Detailed Site Plan DSP-20053-02
Departure from Design Standards DPT-2025-0003
West Hyattsville Phase 2 - ETOD

SUBJECT: Detailed Site Plan DSP-20053-02
Departure from Design Standards DPT-2025-0003
Type 2 Tree Conservation Plan TCP2-2025-0074
Alternative Compliance ACL-2025-0008
Expedited Transit-Oriented Development (ETOD) Project
West Hyattsville Phase 2

The Urban Design Section has reviewed the subject application and presents the following evaluation and findings leading to a recommendation of APPROVAL, with conditions, as described in the Recommendation section of this technical staff report.

Map 13 Block Registration Plan

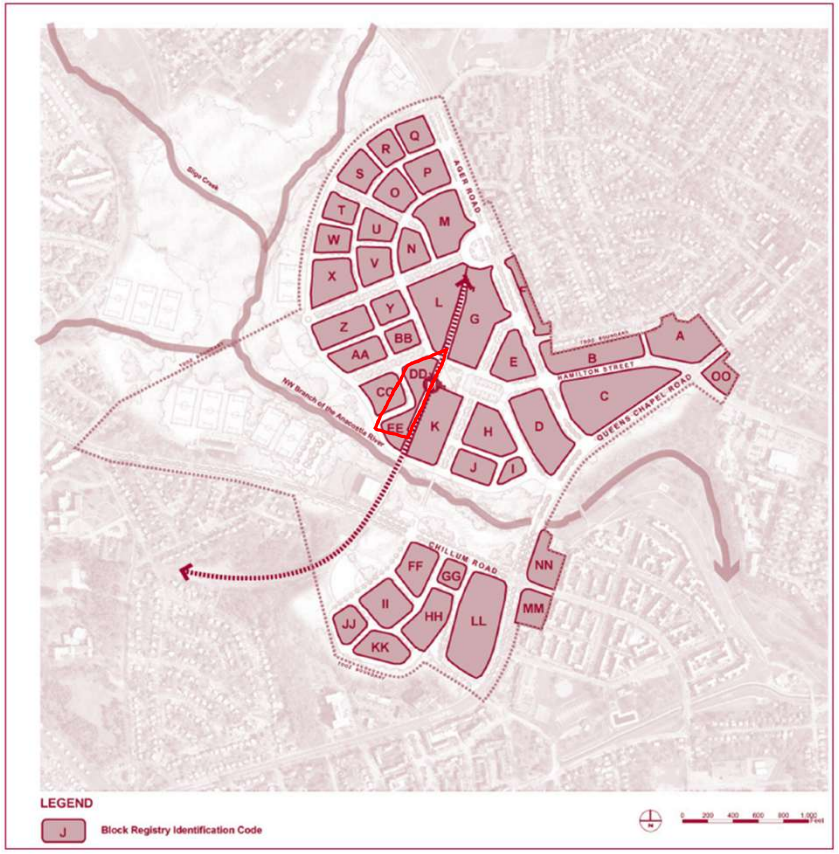
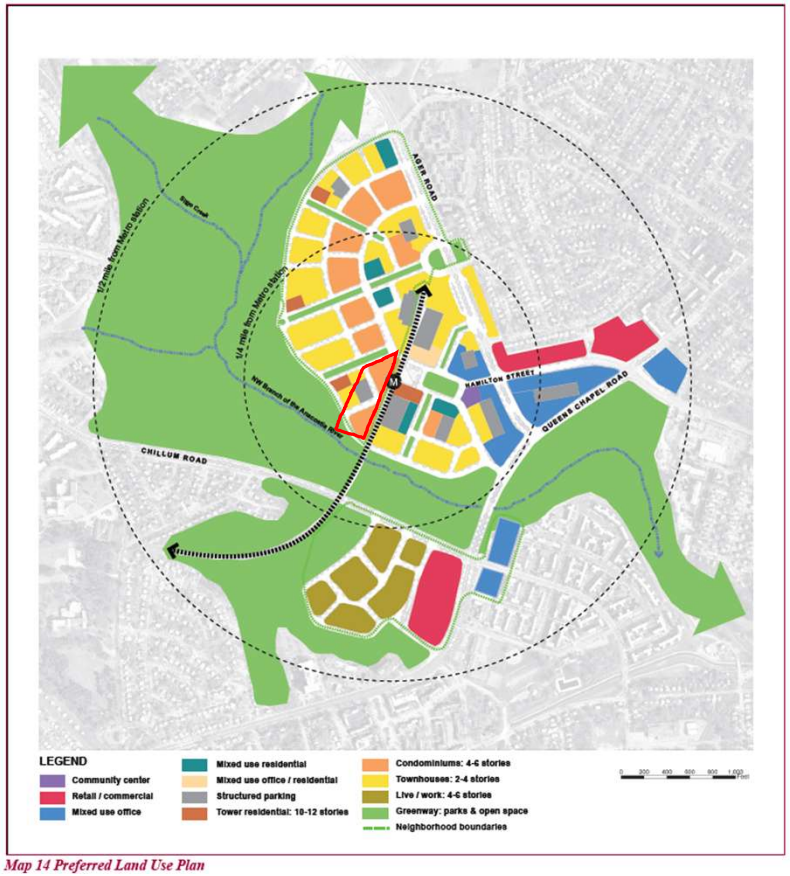
The West Hyattsville TDDP/TDOZMA divides the area into small blocks, which are shown on Map 13, Block Registration Plan (page 35). The subject property, proposed Parcel 2, consists of Blocks DD, EE, and a portion of CC. These blocks were then designated with preferred land use categories, which determine which uses are permitted within each block. On the Preferred Land Use Plan (Map 14, page 36), Blocks DD and EE are designated as "Condominiums: 4–6 Stories", while Block CC (which is split by the boundary of proposed Parcel 2) is a mix of "Structured parking" and "Townhouses: 2–4 stories". The proposed development of multifamily dwellings with structured parking and no ground-floor retail is not in conformance with all of the land use categories on the Preferred Land Use Plan, specifically the Townhouses: 2–4 stories category which does not permit this use. Hence, the applicant requests an amendment to the Preferred Land Use Plan category for the subject property to the Condominiums: 4–6 Stories category for the entirety of proposed Parcel 2 with this DSP. The applicant's proposed amendment to the Preferred Land Use Plan Category reflects the current development pattern of the surrounding property and takes into account the contemporary real estate market and the difficulty of executing the development concept of the West Hyattsville TDDP. The alternative design continues established neighborhood block patterns benefiting the development and meets the vision

For these reasons, staff find that the proposed change to the Preferred Land Use Plan will not substantially impair implementation of the TDDP. Accordingly, staff recommend **approval** of the changes to the Preferred Land Use Plan category for the subject property.

TAX MAP: 41, E4	ZONING CATEGORY: M-X-T/TDO
WSSC 200' SHEET: 206NE02 207NE02	
SITE DATUM HORIZONTAL: NAD83 VERTICAL: NGVD1929	
1" = 30'	DATE: APRIL, 2021
SHEET 3 OF 4	DESIGNED: YOR TECHNICIAN: YOR CHECKED: DJB CAD STD'S. VERSION: V8 / NCS
PROJECT NO. 0706-06-00

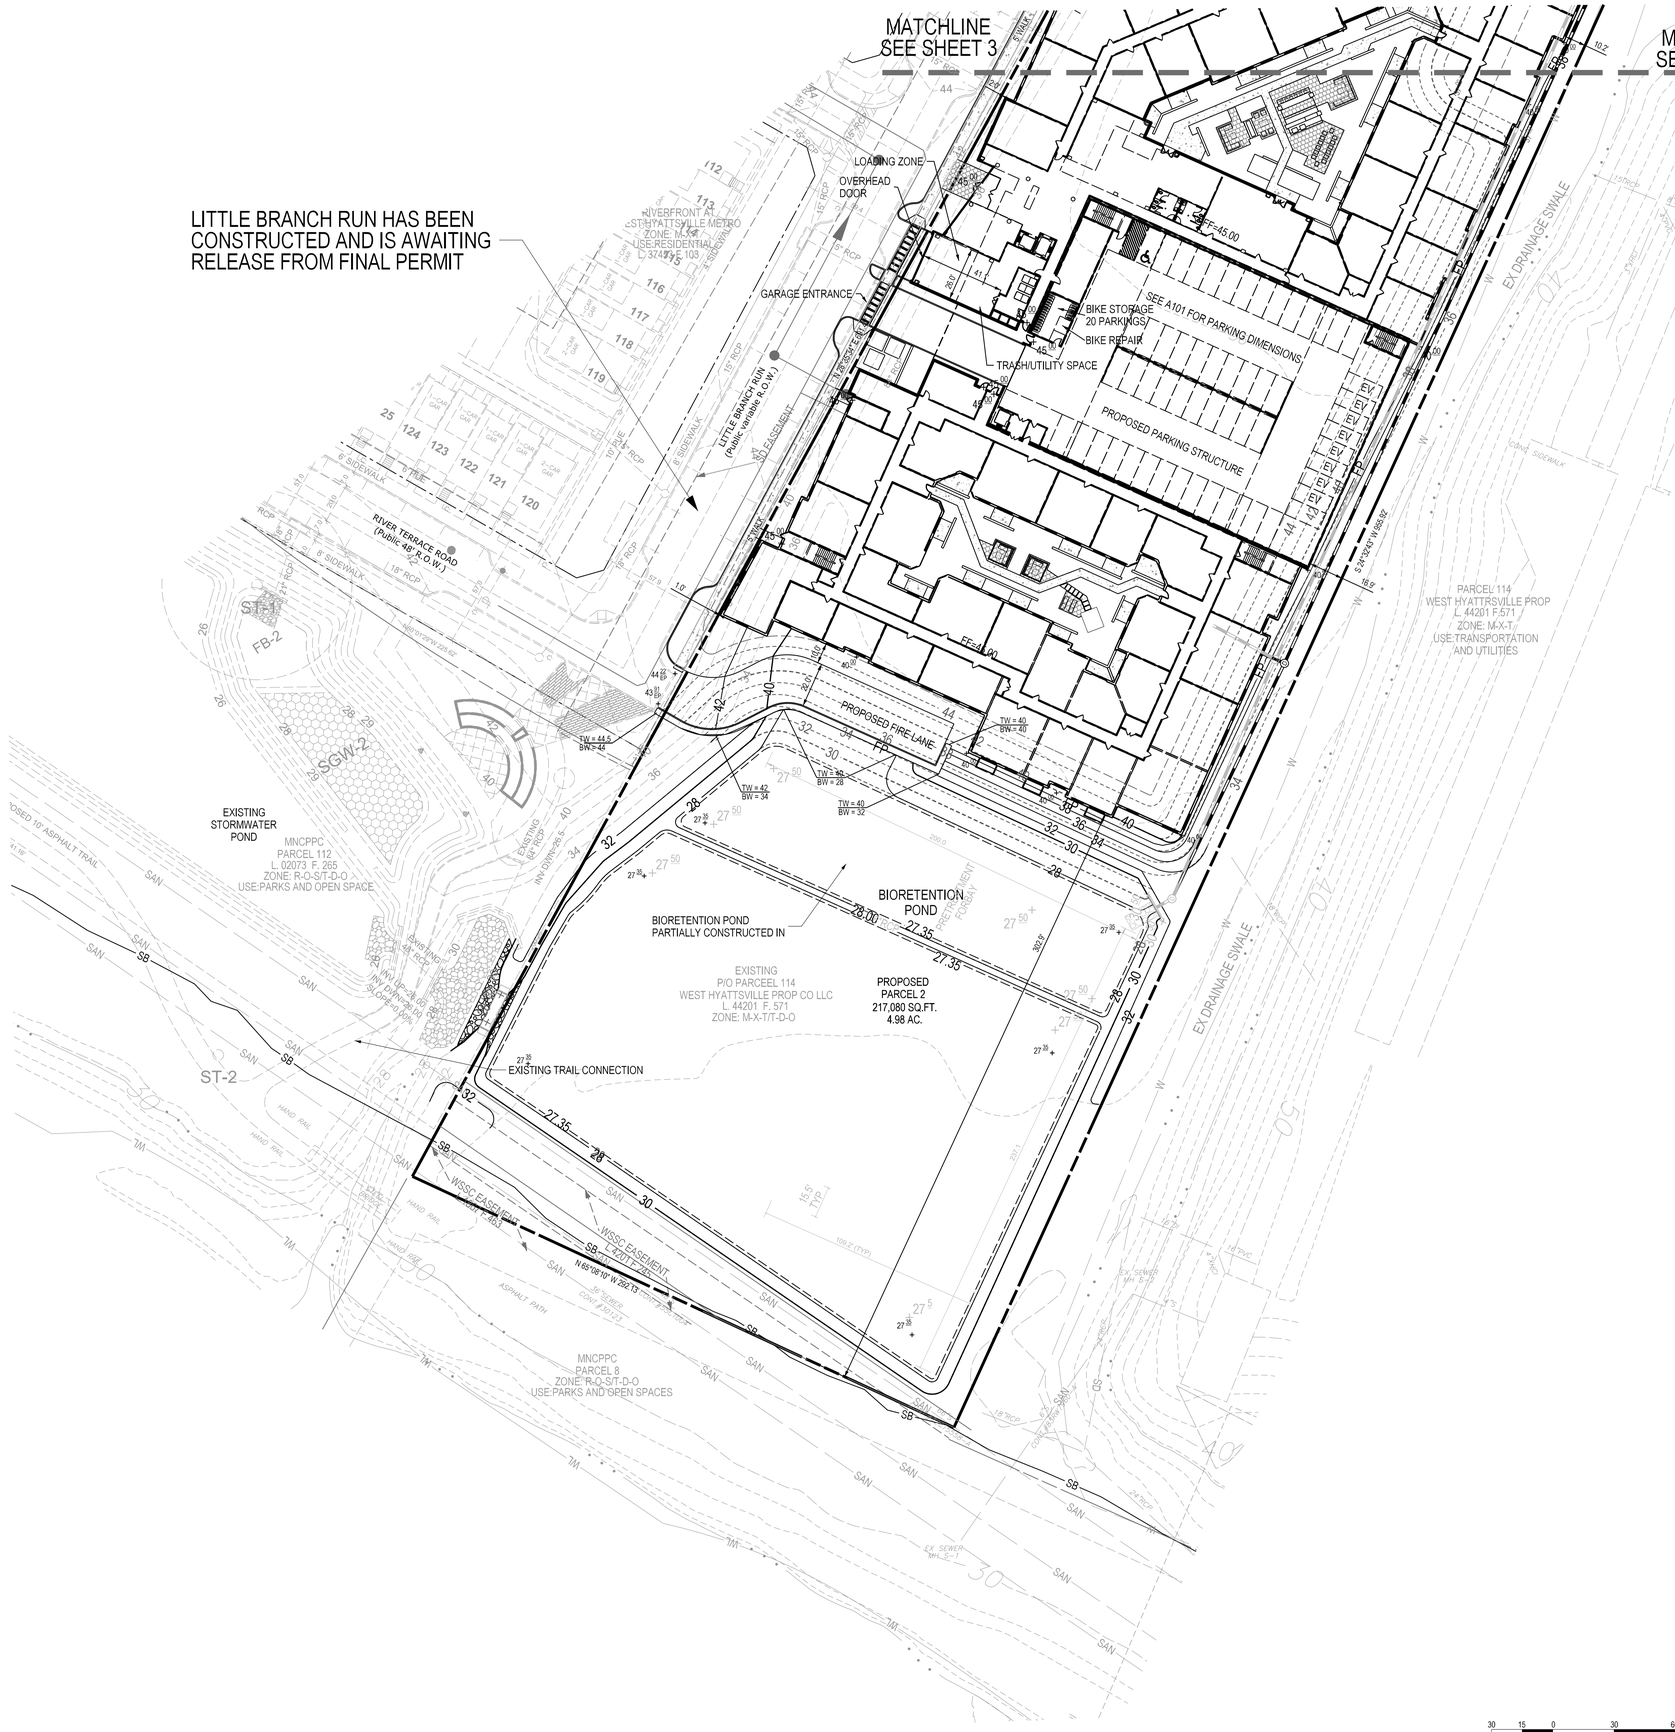
The extension of the 5-foot-wide sidewalk along the subject property's frontage of Little Branch Run until the point of vehicle entry for Parcel 2 and to the Northwest Branch Trail is identified on Sheets 3 and 4 of the DSP. The bicycle parking in the parking garage, for residential uses and on-site or in the right-of-way for nonresidential uses that are consistent with the standards of the 2006 *Approved Transit District Development Plan and Transit District Overlay Zoning Map Amendment for the West Hyattsville Transit District Overlay Zone* (West Hyattsville TDDP), and the bicycle fix-it station proposed within the garage is identified on Sheet 4. Continental style crosswalks crossing the garage and loading zone access points are identified on Sheet 4. The pedestrian and bicycle shared-use path through Parcel 1, from the western side of the subject site near Emerald Branch Drive, to the pedestrian tunnel to the West Hyattsville Metro Station, is identified on Sheets 3 and 4. This condition has been met.

Comment: While the West Hyattsville Metro Connector Trail is not a master planned facility, the site plan identifies the existing eight-foot-wide shared use path along eastern side of subject property, on sheet 3. The shared use path will provide connections from West Hyattsville Metro to the subject property.

Comment: The site plan includes a five-foot-wide sidewalk along the frontage of Little Branch Run and an eight-foot-wide sidewalk along the eastern side of subject property on sheets 3 and 4. A shared-use path is also provided through the property from the western side of the subject site near Emerald Branch Drive to the pedestrian tunnel for the West Hyattsville Metro Station, shown on sheets 3 and 4. Staff recommend ADA curb ramps at vehicular crossings. These facilities meet the intent of the policy.

Comment: The site plan includes a shared-use path through the property from the western side of the subject site near Emerald Branch Drive to the pedestrian tunnel to the West Hyattsville Metro Station, shown on sheets 3 and 4. These facilities meet the intent of the policy.

TAX MAP	ZONING CATEGORY:
41, E4	M-X-T/TDO
WSSC 200' SHEET: 206NE02, 207NE02	
SITE DATUM HORIZONTAL: NAD83 VERTICAL: NGVD1929	
1" = 30'	DATE: APRIL 2021; DESIGNED: YOR; TECHNICIAN: YOR; CHECKED: DJB; CAD STD'S VERSION: V8 / NCS
SHEET 4 OF 4	
PROJECT NO. 0706-06-00

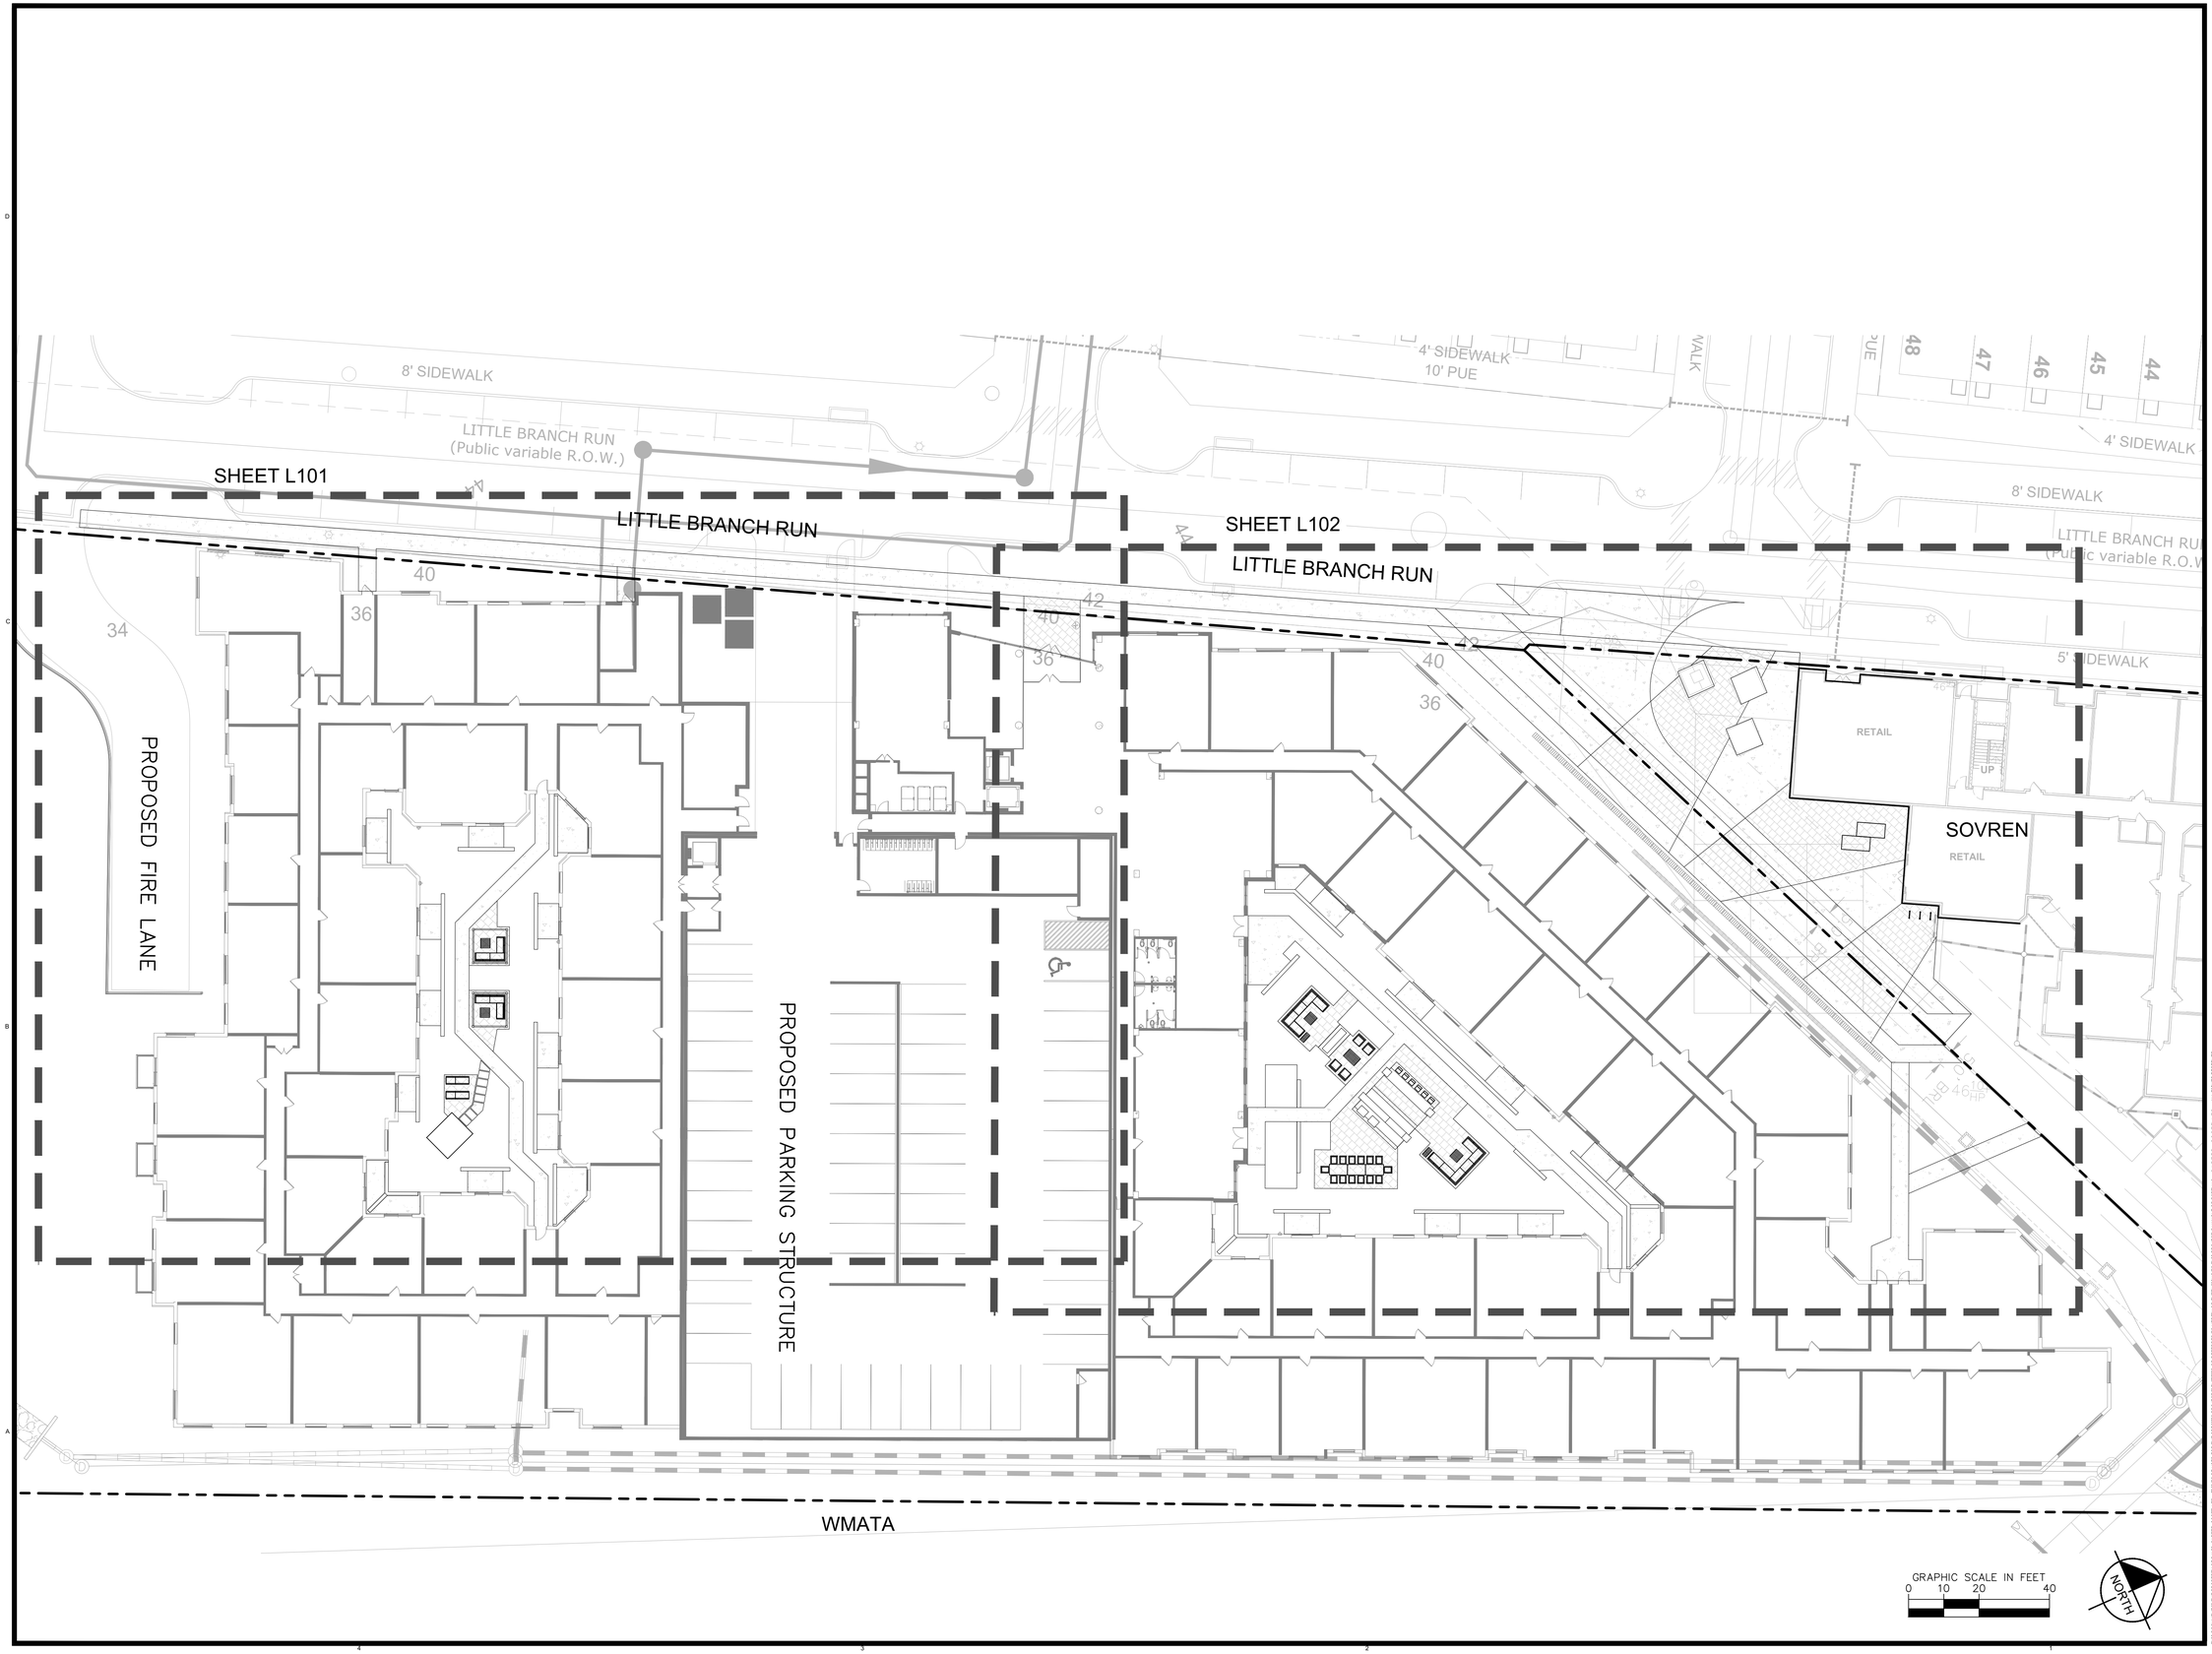
side of subject property on sheet 4. The sidewalk provides connections from Northwest Branch Trail to the subject property.

Comment: While the Riverfront Connector is not a master planned facility, the site plan identifies this as a five-foot-wide sidewalk that connects with the Northwest Branch Trail along the southern portion of the subject property, shown on sheet 4.

A301

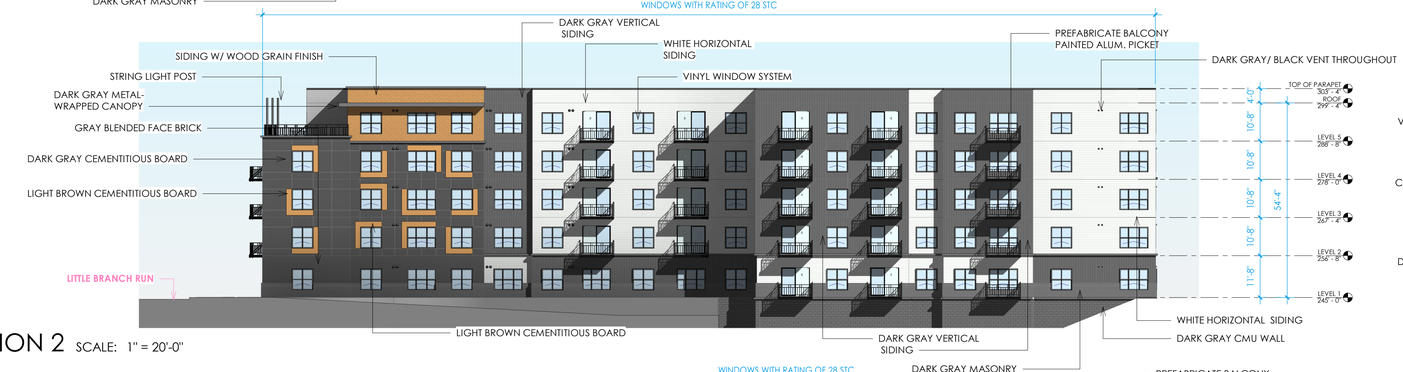
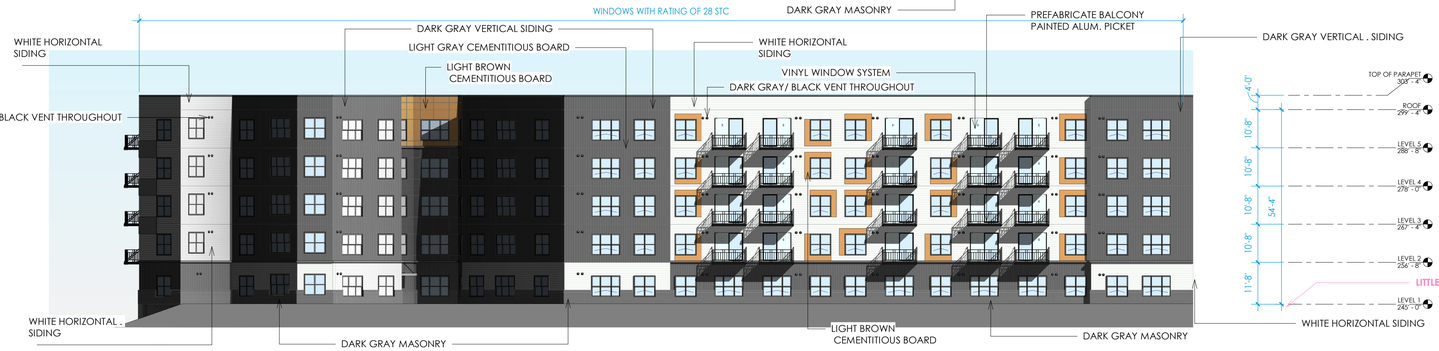
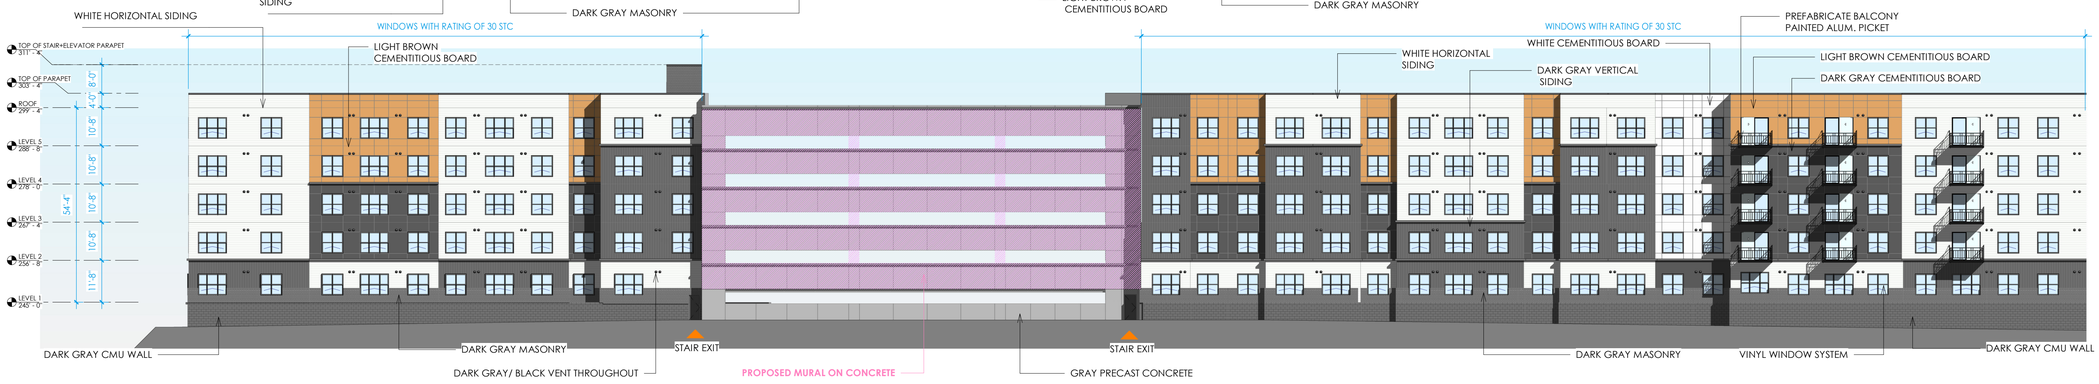
5. Buildings shall be designed to orient views towards the street and public realm.	The building is designed to orient views towards the public realm, with the front along Little Branch Run featuring balconies (see Drawing A301) that offer views of the street and surrounding public spaces. This approach enhances the connection between the building and its environment, fostering a stronger relationship with the community.
